Hallsville School District

All Purpose Field & Parking Lot
Primary School Classroom Addition
Secure Entry Doors

Progress Report #6

RFI Number:	4
Date:	07/02/2026
A/E Project No.:	24-5017
Contractor Project No.:	
Project Name:	Classroom & Secure Entrance

4 NORTH PARKING LOT ENTRANCE DEMOLITION ELEVATION
1/4" = 1'-0"

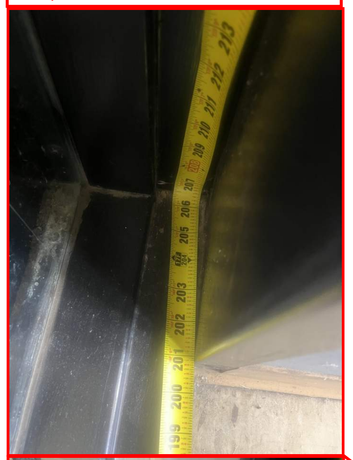
Q1) The existing North Parking Lot storefront had an unforeseen wood header above the storefront. We recommended removing this wood header and framing a new metal stud header with drywall and kickers that are attached to the joists above, for a cleaner look. The school agreed that we could proceed with this work.
Design team, please confirm that is acceptable.

Q1) The existing North Parking Lot storefront had an unforeseen wood header above the storefront. We recommended removing this wood header and framing a new metal stud header with drywall and kickers that are attached to the joists above, for a cleaner look. The school agreed that we could proceed with this work.

Design team, please confirm that is acceptable.

Q1) Replacing the wood header with a new metal stud header with drywall and kickers is acceptable.

5 MIDDLE SCHOOL CENTRAL OFFICE ENTRANCE DEMOLITION ELEVATION
1/4" = 1'-0"

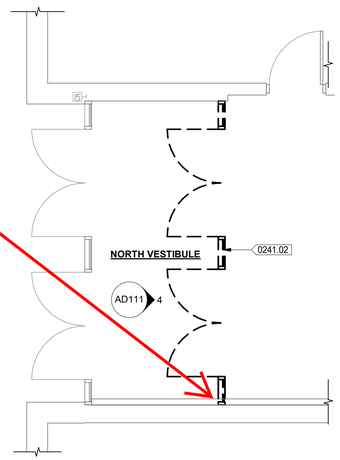
Q3) After the Middle School Entrance storefront frame was removed, we realize the block was not flush. The demo/general works contractor recommended filling the void space in the block with ground in order to make the end of the block. Then, the Glazing subcontractor would install a 50mil sheet metal trim piece that will match the storefront frame in order to hide the block. The school agreed that we could proceed with this work.

Q3) After the Middle School Entrance storefront frame was removed, we realize the block was not flush. The demo/general works contractor recommended filling the void space in the block with ground in order to make the end of the block. Then, the Glazing subcontractor would install a 50mil sheet metal trim piece that will match the storefront frame in order to hide the block. The school agreed that we could proceed with this work.

Design team, please confirm that is acceptable.

Q3) Filling the void in the block wall and installing a 50 mil sheet trim piece is acceptable.

1 NORTH PARKING LOT ENTRANCE DEMOLITION PLAN
1/4" = 1'-0"

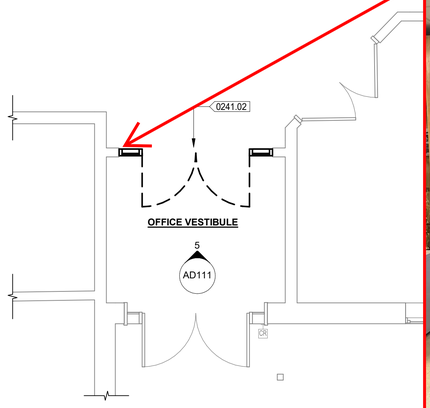
Q2) The existing North Parking Lot storefront was ticked into a pocket in the wall. The new plans call for the new storefront to also be tucked in this pocket. We asked the design team and school if it is acceptable to close that pocket up with drywall, so the storefront is flush with the wall. This will help with cleaning, getting things stuck in the space, etc. The school agreed that we could proceed with this work.
Design team, please confirm that is acceptable.

Q2) The existing North Parking Lot storefront was ticked into a pocket in the wall. The new plans call for the new storefront to also be tucked in this pocket. We asked the design team and school if it is acceptable to close that pocket up with drywall, so the storefront is flush with the wall. This will help with cleaning, getting things stuck in the space, etc. The school agreed that we could proceed with this work.

Design team, please confirm that is acceptable.

Q2) Closing the pocket with drywall is acceptable. Ensure new storefront wall matches new dimension.
